TEMPORARY DRAWING-NOT RELEASED FOR PRODUCTION

THIS IS A SUGGESTED DESIGN FOR CUSTOMER APPROVAL. FINAL SIZES AND VOLUME ARE SUBJECT TO MOULDING SPECIFICATIONS AND PRODUCTION QUALIFICATIONS.

CAPACITY TO FILL LEVEL: 177 ml ± 6	
OVERFLOW CAPACITY: 191.5 ml ± 6 (D1) (G1)	
NECK FINISH: M24-410 SPECIAL	WEIGHT: 20g ± 1.5 (C1)
DRAWN BY: CML	DESC. 6 OZ Bullet
SCALE: 1:1 DATE: 5/5/22	DRAWING NO. 44223-8G
BOTTLE MAT'L: PETE	MOULD NO.
CAD NAME:PD

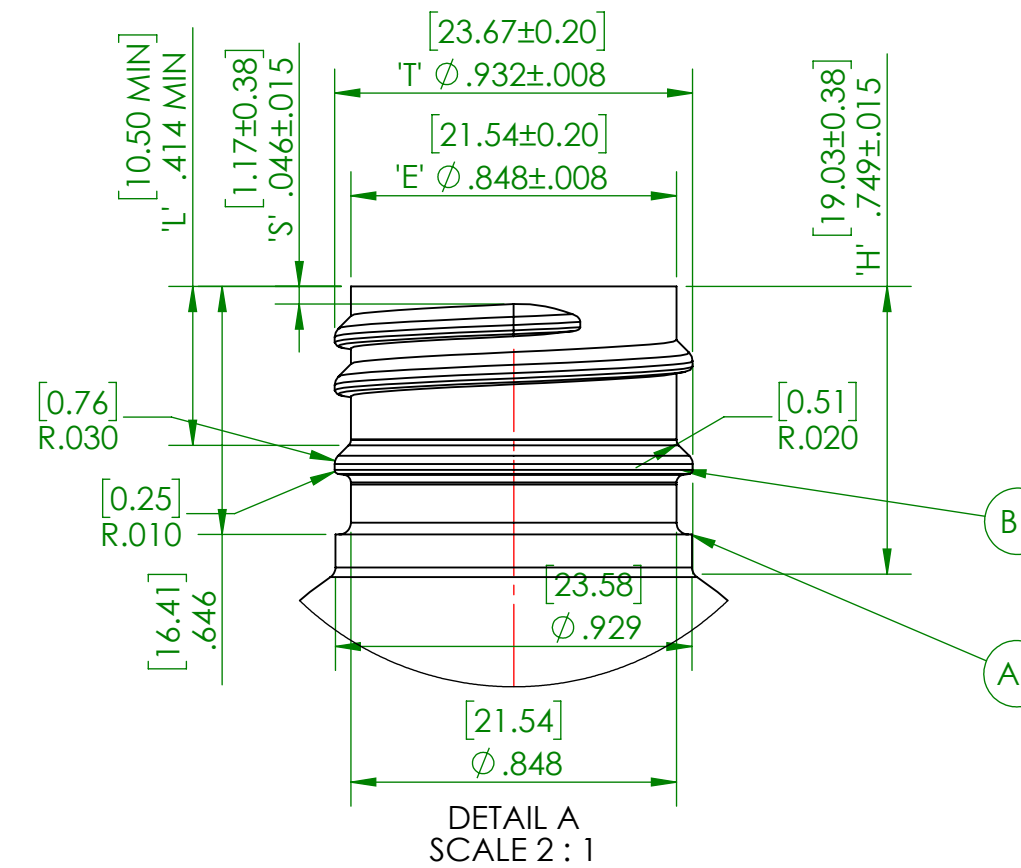
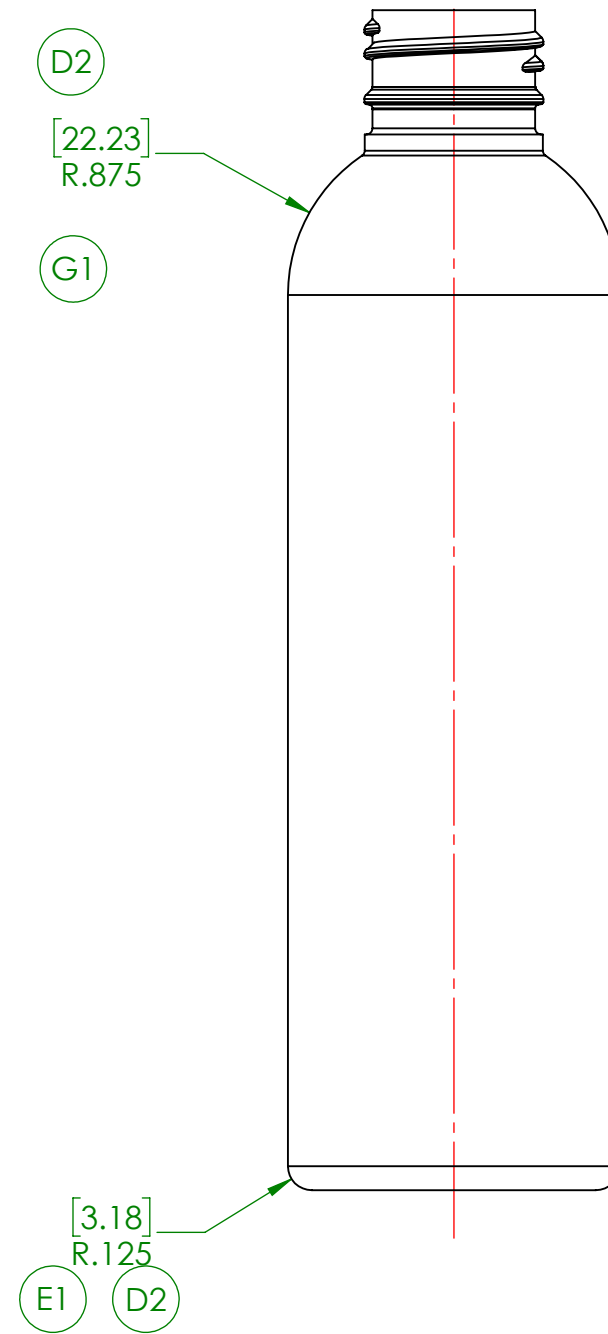
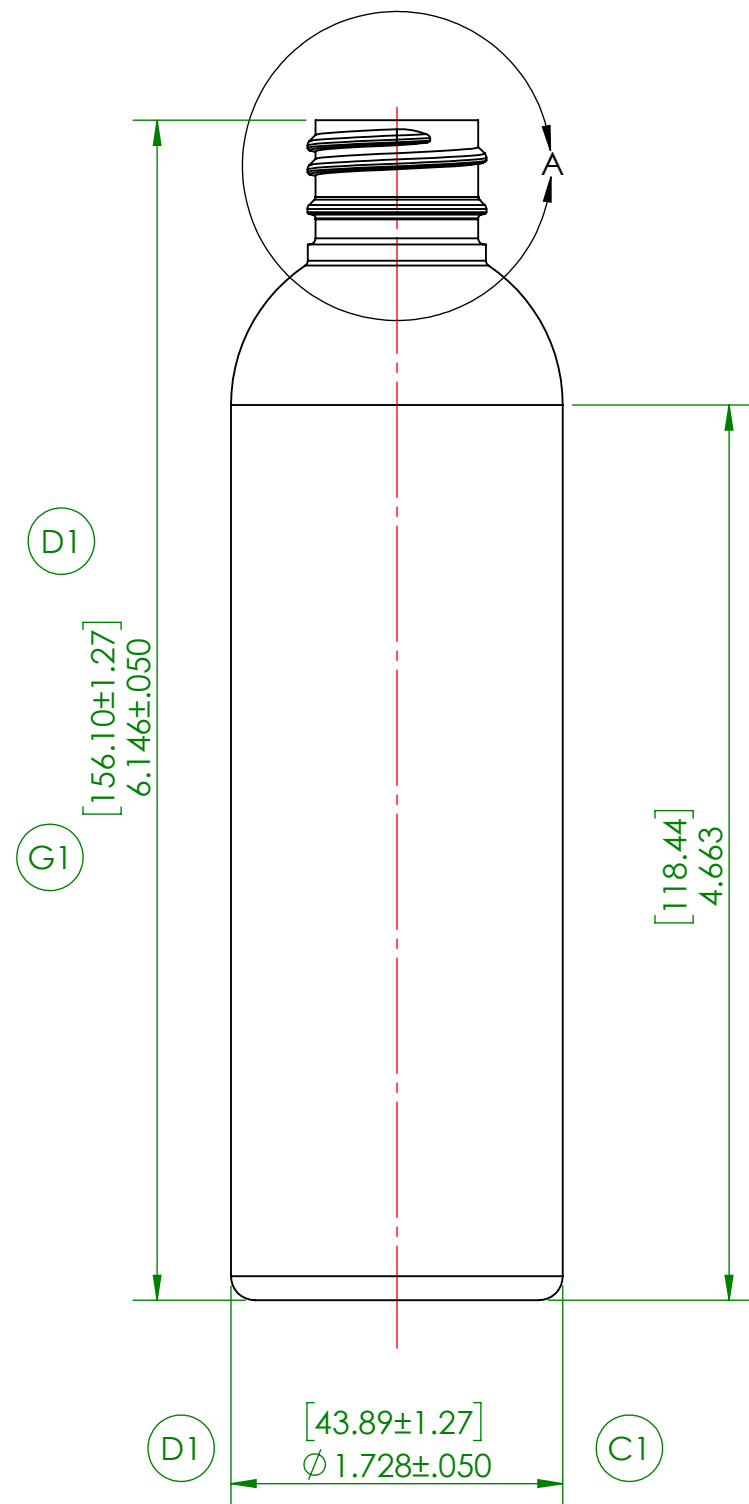
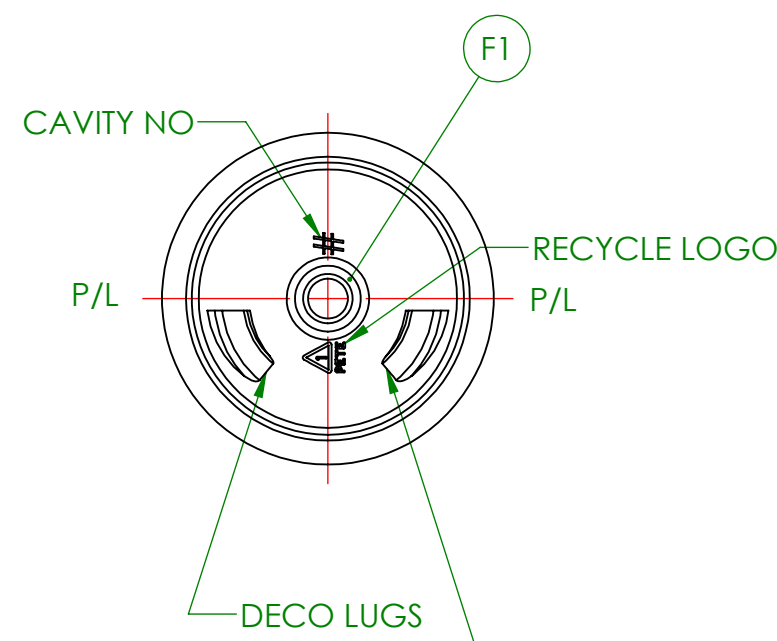
NO.	BY	DESCRIPTION	DATE
A1	CML	ADDED STEP AT BASE OF NECK	MAY.24/22
B1	CML	CHANGED SHAPE OF NECK RING	JUNE.3/22
C1	CML	OD WAS 1.710" WEIGHT WAS 15g	JUNE.17/22
D1	CML	OAH WAS 6.102" OD WAS 1.735" OFC WAS 192ml	JUNE.23/22
D2	CML	RADIUS WAS 0.750" AND 0.200" NOW 0.938" AND 0.172"	JUNE.23/22
E1	CML	RADIUS WAS 0.172"	JUNE.23/22
F1	CML	ADDED SECOND PUSHUP	JUNE.24/22
G1	CML	RADUIS WAS 0.938" OAH WAS 6.260" OFC WAS 195ml	JUNE.27/22
